# Memorandum

To	Douglas Shire Council and Department of State Development, Manufacturing, Infrastructure and Planning		
From	Sarah Wilson - GHD	Tel	+61 7 5413 8133
Subject	Response to information request from Douglas Shire Council (DSC) and Department of State Development, Manufacturing, Infrastructure and Planning (DSDMIP) Wangetti Trail SP1 - Combined Development Application Response to request for information 1909-13127 SRA	Job no.	4132458

We refer to the Development Application Council Ref: CA3212/2019 and SARA Ref:1909-13127 SRA associated with the proposed Wangetti Trail SP1 and provide responses to the information request issued by Douglas Shire Council (DSC) and Department of State Development, Manufacturing, Infrastructure and Planning (DSDMIP) in accordance with Part 3, Section 13.1 of the Development Assessment Rules.

**Table 2 Justification for the location of the proposed trail**

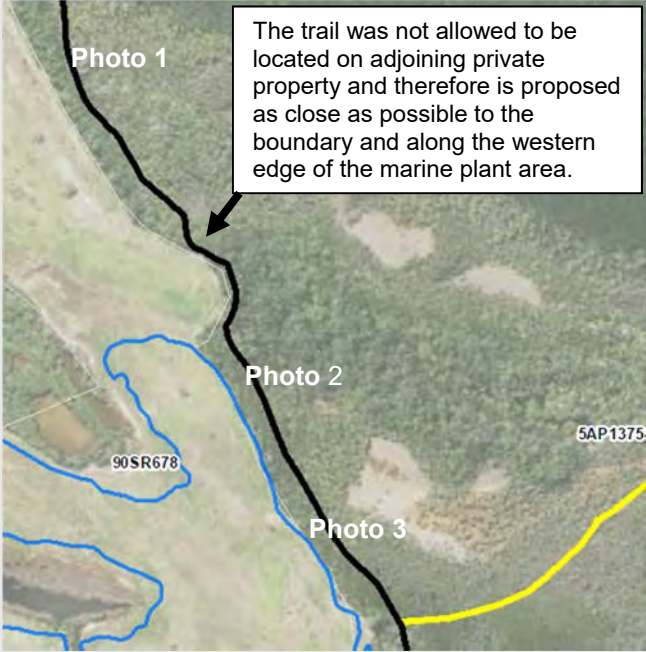
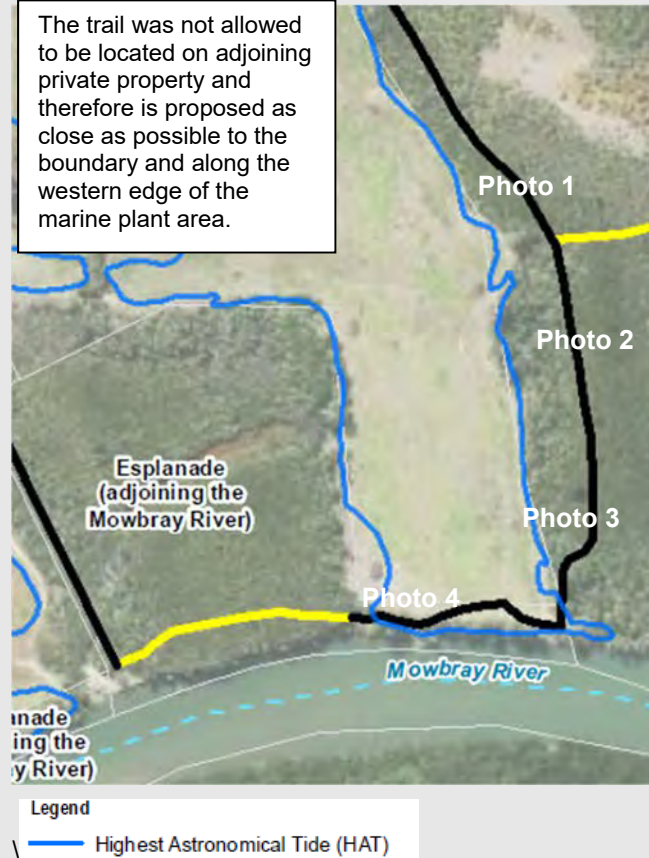
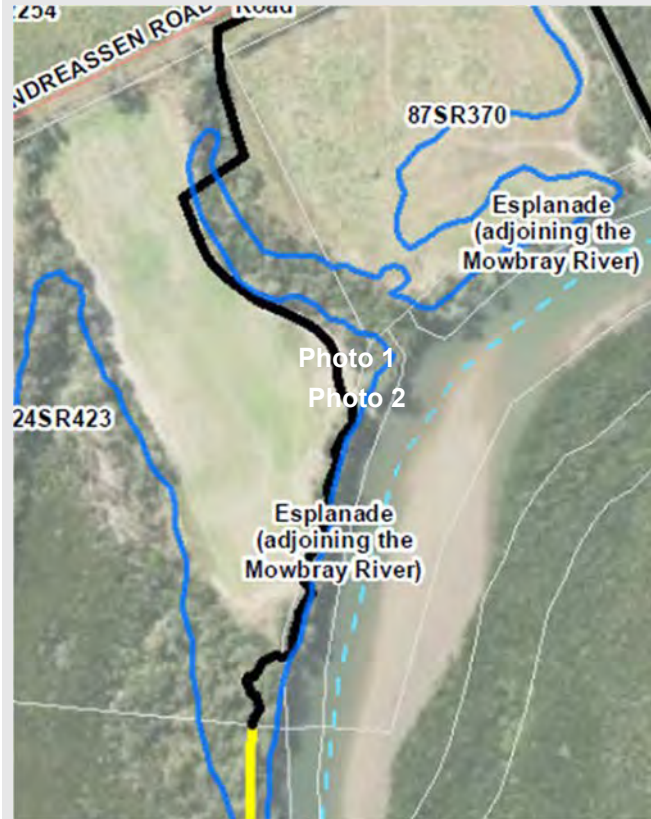
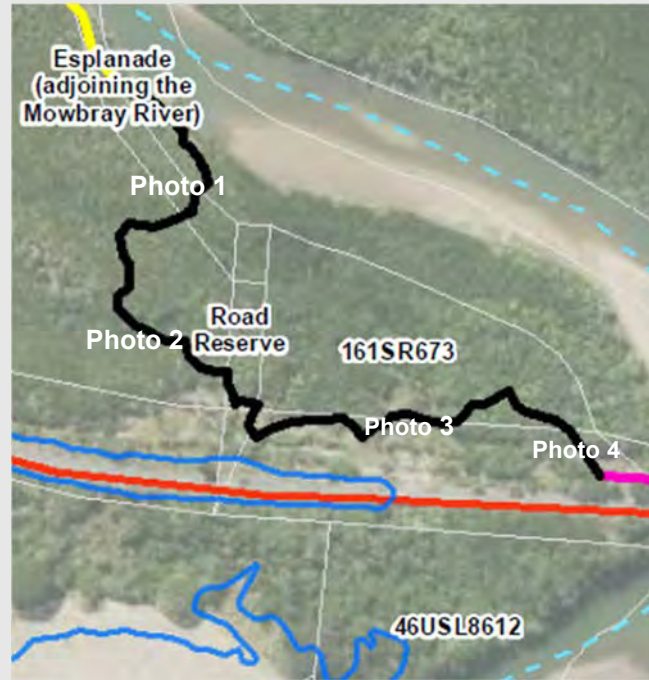
- b) *Provide maps identifying all locations where the trail will be constructed within TEC communities.*
- c) *Identify all locations where crushed rock will be used to construct the track and any creek crossings where rocks are proposed.*
- d) *Provide detailed information of the compacted trail construction and the impacts it will have to the existing profiles of tidal land.*
- e) *Demonstrate the compacted trail will not impact tidal flow and fragment tidal lands.*
- f) *Provide information of the existing tidal land levels (i.e. contour lines).*
- g) *Discuss the natural tidal inundation levels and connectivity of all adjacent habitat under elevated flow events. This discussion should include any impacts the proposed works will have on the existing connectivity.*
- h) *Discuss all potential impacts the proposed works will have on marine plants and fisheries resources.*

Location – proposed trail only	Photo of location	Comments
<p><b>Structure B38 to Lot 5 AP13754</b></p>  <p>The trail was not allowed to be located on adjoining private property and therefore is proposed as close as possible to the boundary and along the western edge of the marine plant area.</p> <p><b>Legend</b></p> <ul style="list-style-type: none"> <li>— Highest Astronomical Tide (HAT)</li> <li>— Mean High Water Springs (MHWS)</li> </ul>	<p>Photo 1</p>  <p>Photo 2</p>  <p>Photo 3</p> 	<p>Trail has been proposed in this section, as there are existing informal tracks that can be used which are in a suitable condition for a trail. This area is below HAT level and above the MHWS level. The alignment has been located as far landward as possible near the boundary of the adjoining property properties. The alignment is located on land with an elevation of approximately 1 m AHD. HAT has been determined to be at 1.857 m (AHD) with MHWS at 0.977 m (AHD). Furthermore, the trail has been proposed to be located on the edge of the marine plant area where possible.</p>

The trail was not allowed to be located on adjoining private property and therefore is proposed as close as possible to the boundary and along the western edge of the marine plant area.

Trail has been proposed in this section, as there are existing cleared areas and access tracks through mangroves that can accommodate a trail. Sections of the trail have been located as far landward as possible near the boundary of the adjoining property properties. The alignment is located on land with an elevation of approximately 1 m to 3 m AHD. HAT has been determined to be at 1.857 m (AHD) with MHWS at 0.977 m (AHD). Furthermore, the trail has been proposed to be located on the edge of the marine plant area where possible

Trail has been proposed in this section, as there are existing informal tracks and cleared areas that are in a suitable condition to be used. This section is above the MHWS. This section of the trail is mostly located above the HAT level, with the exception of where it crosses the waterway on Lot 24 SR423. It has also been designed to have minimal impact on marine plant communities.

The alignment has been located as far landward as possible. The alignment is located on land with an elevation of approximately 1 m AHD and section of the trail is located below HAT level. Furthermore, the trail has been proposed to be located on the edge of the marine plant area where possible.

**Figure 1 Map showing the alternative options considered for SP1**

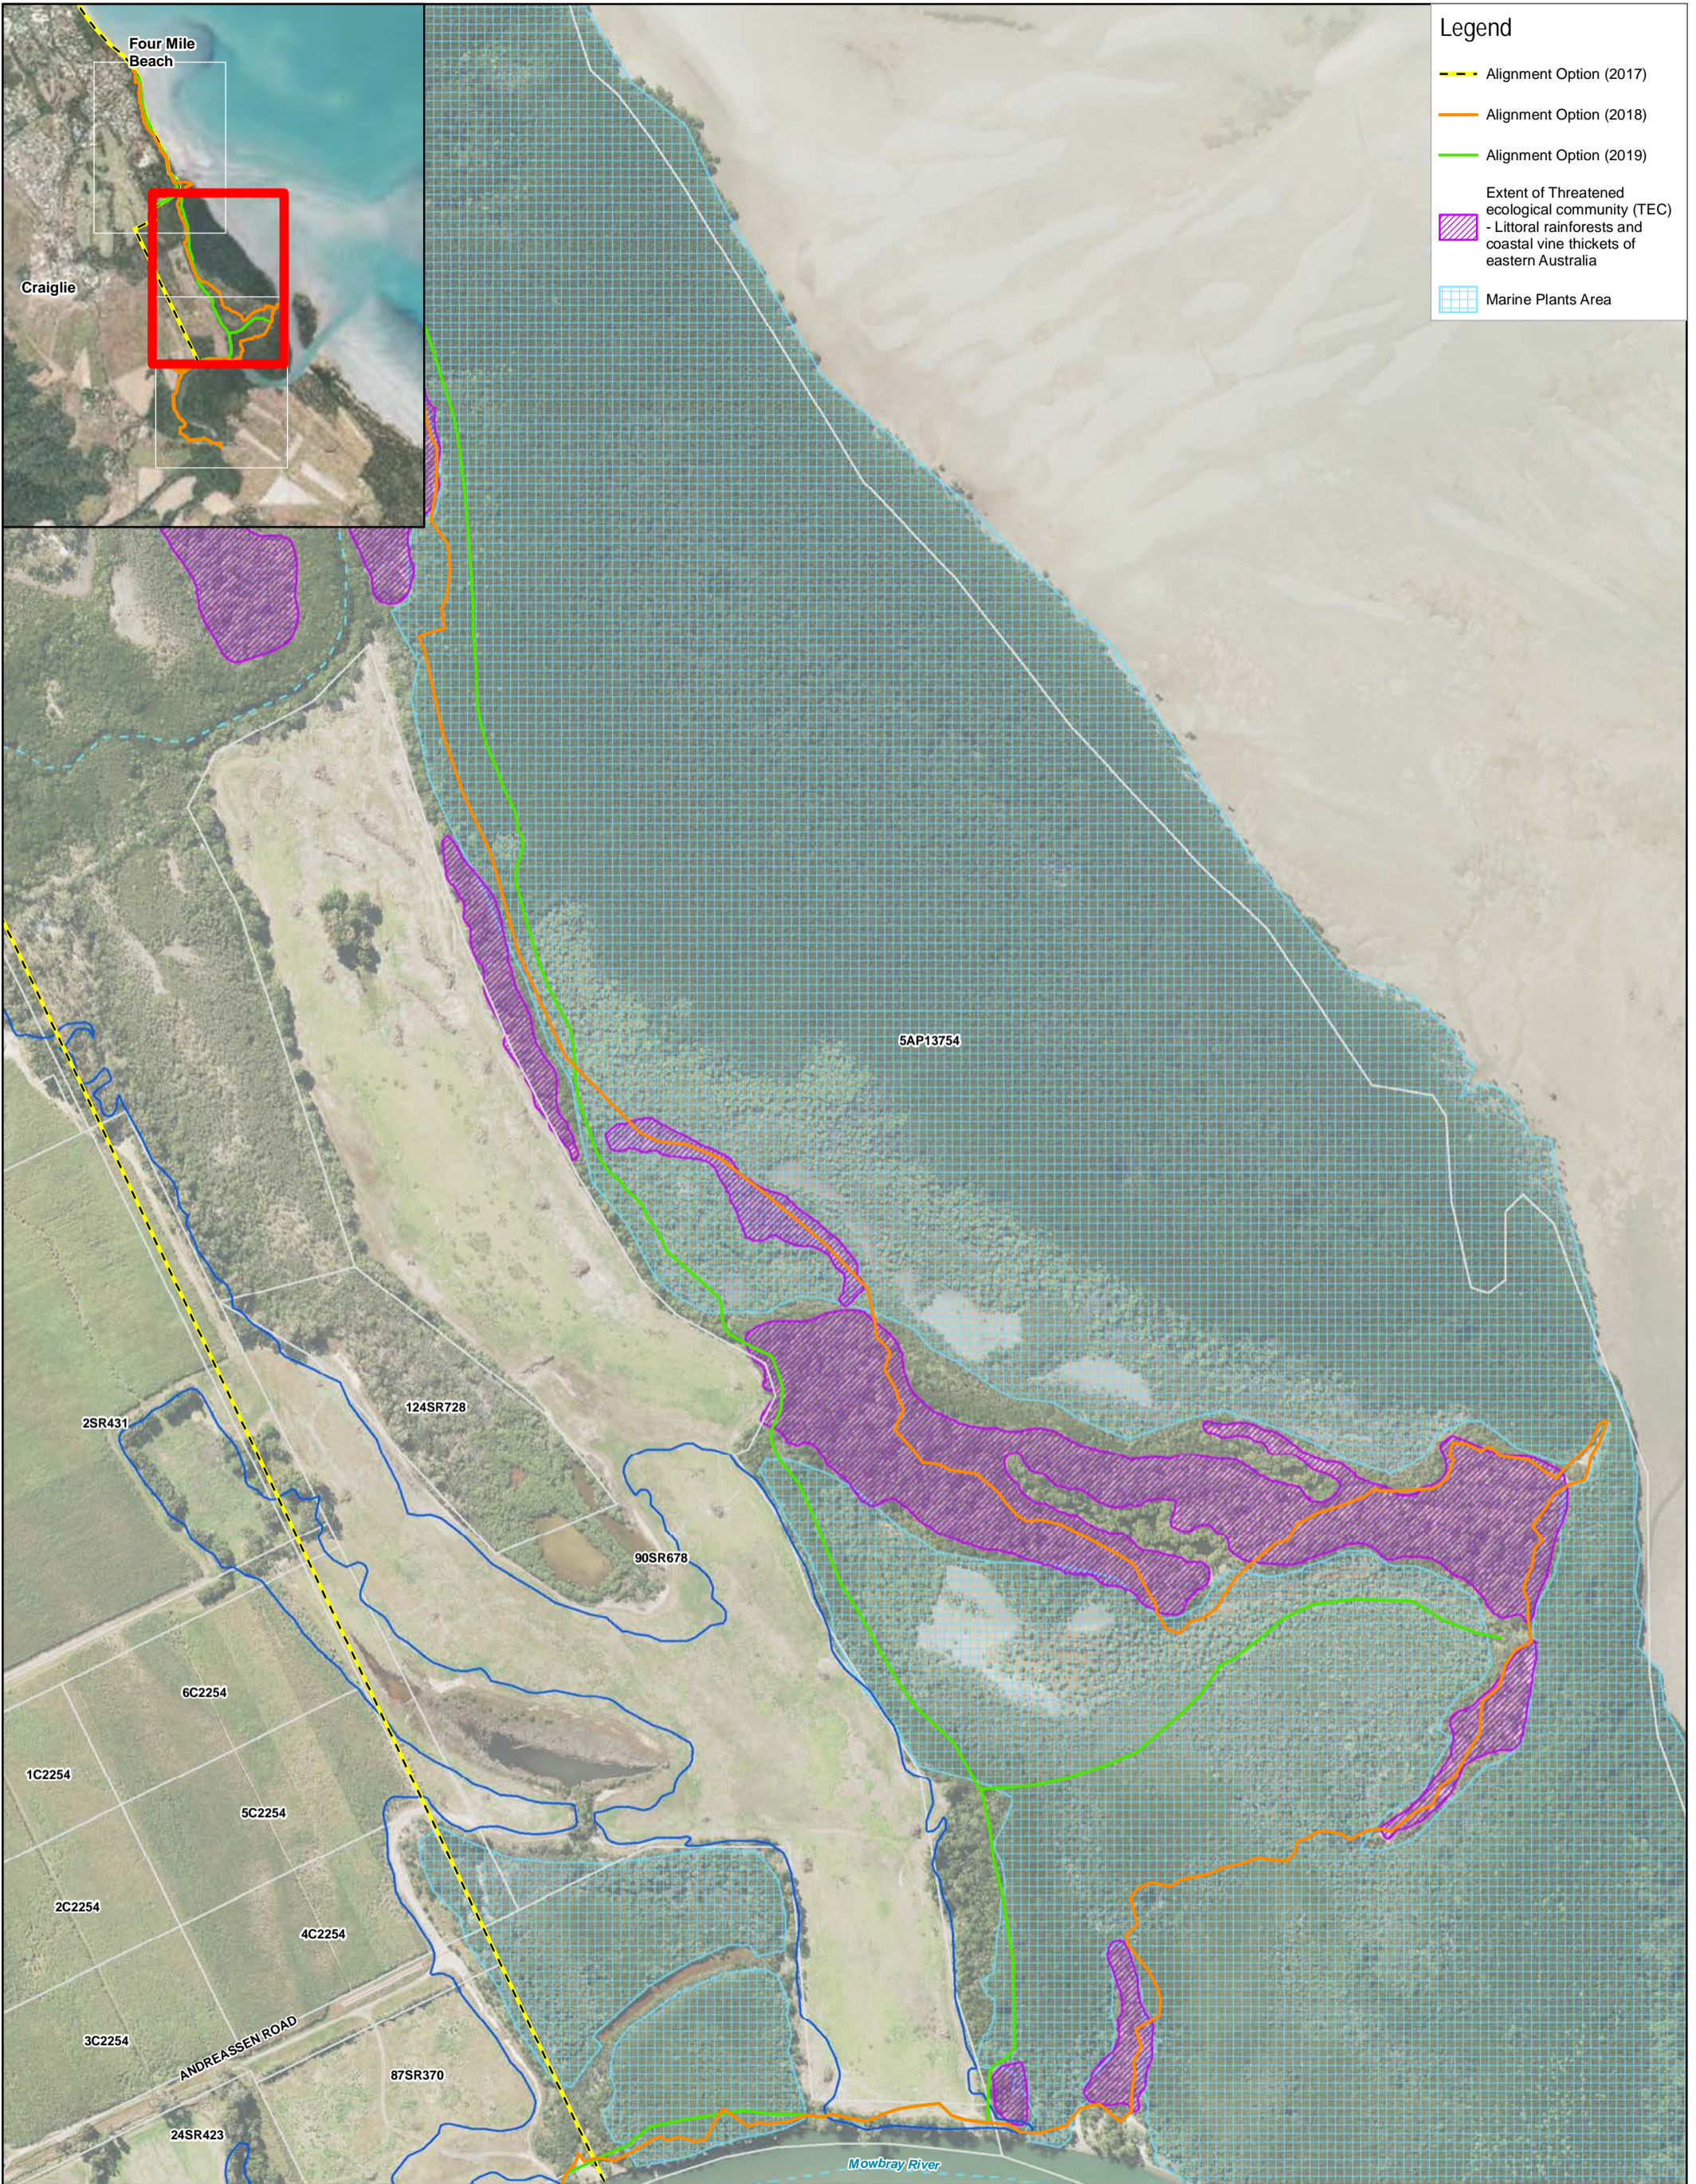
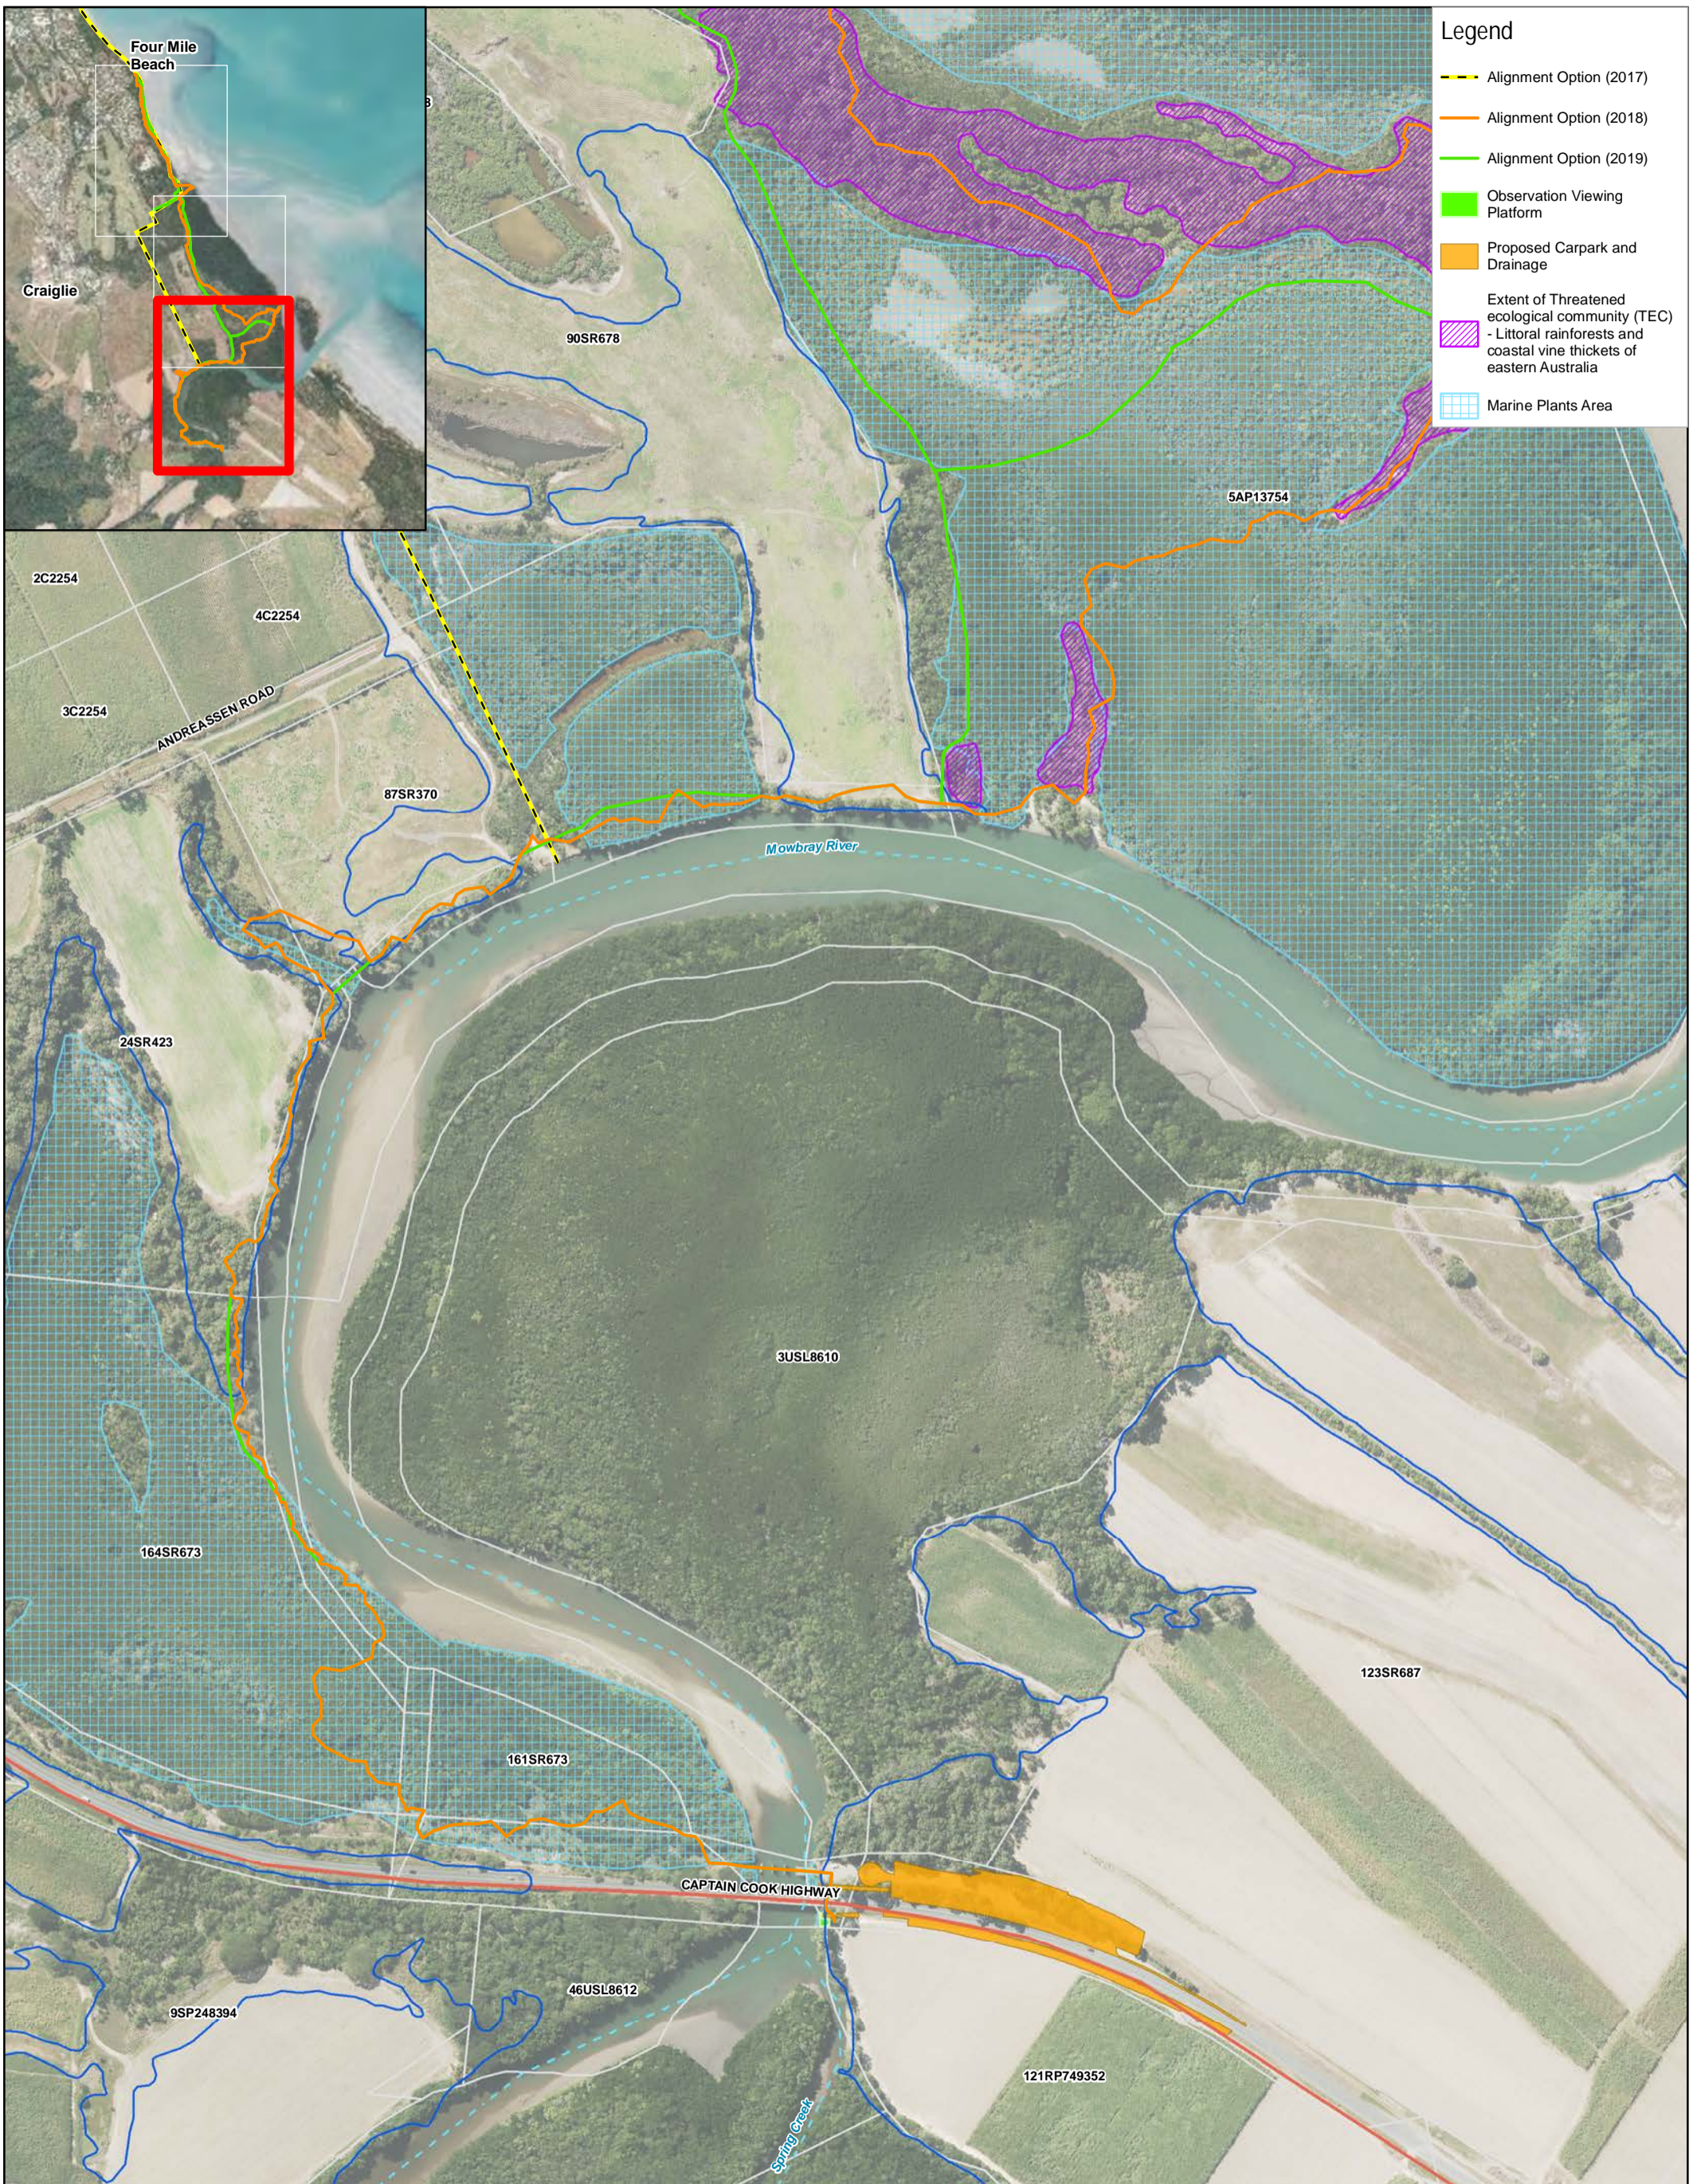
- Identify on scaled maps the trail alignment for Alternative A and Alternative B and provide the permanent and temporary marine plant disturbance areas in meters squares (m<sup>2</sup>).
- Demonstrate that no alternative trail alignments or construction alternatives exist that will avoid impacts on marine plants and fisheries resources (i.e. raised boardwalk).
- Discuss why areas of cleared land, existing informal tracks and land above the level of HAT within Lot 90 on SR678, Lot 87 on SR370 and Lot 24 on SR423 and the road reserve of Captain Cook Highway have not been used for the trail alignment.

### Response to Item 1 (a) Identify on scaled maps the trail alignment for Alternative A and Alternative B and provide the permanent and temporary marine plant disturbance areas in meters squares (m<sup>2</sup>).

As discussed in Section 3.3 of the SP1 Wangetti Mowbray North Marine Plant Report 2019, multiple alternatives were considered as part of the trail and boardwalk alignment. Alternative A and Alternative B are depicted on Figure 1. A description of the alternative alignments have been discussed in Table 1, including a breakdown of Permanent Marine Plant Disturbance (PMPD) and Temporary Marine Plant Disturbance (TMPD) for alternative alignments vs chosen alignment.

The initial design incorporated a loop where the trail branches off the main trail within Lot 5 on AP13754 (Refer to **Figure 1**). This has been changed to a single branch to substantially reduce the area of impact on marine plants. Other design, maintenance and restoration measures proposed to minimise and mitigate impacts on marine plants are outlined below:
